# MIDTOWN COLLECTION AT HANNAH RIDGE FILING NO. 1

# A REPLAT OF TRACT BB OF HANNAH RIDGE AT FEATHERGRASS FILING NO. 1, RECEPTION NO. 214713468, RECORDS OF EL PASO COUNTY, COLORADO, SECTION 32, TOWNSHIP 13 SOUTH, RANGE 65 WEST OF THE SIXTH PRINCIPAL MERIDIAN, EL PASO COUNTY, COLORADO

MIDTOWN COLLECTION AT  
HANNAH RIDGE FILING NO. 1  
JOB NO. 1116.30  
JANUARY 15, 2019  
SHEET 1 OF 3

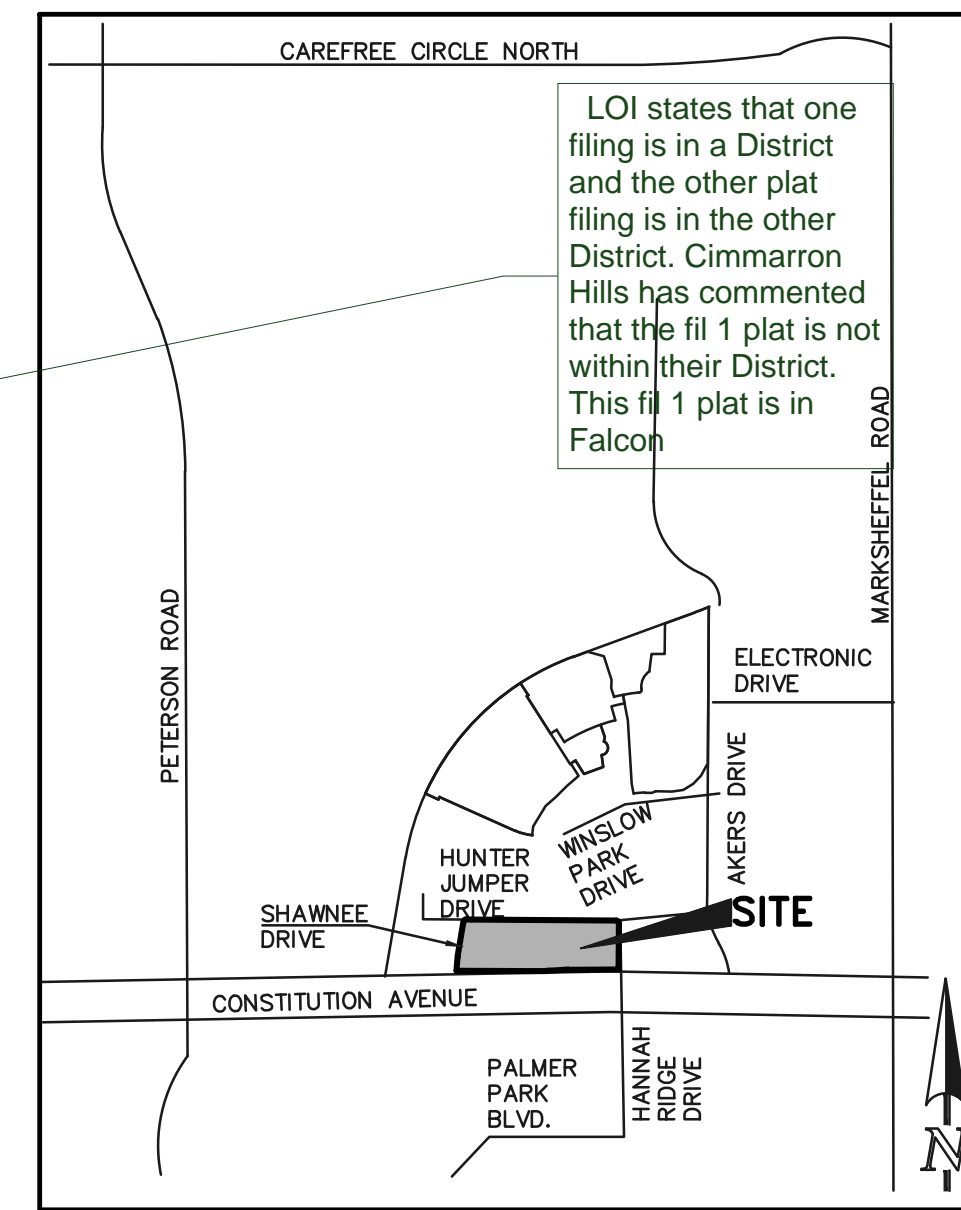
Noise wall should be identified by note and installation and maintenance of that noise wall
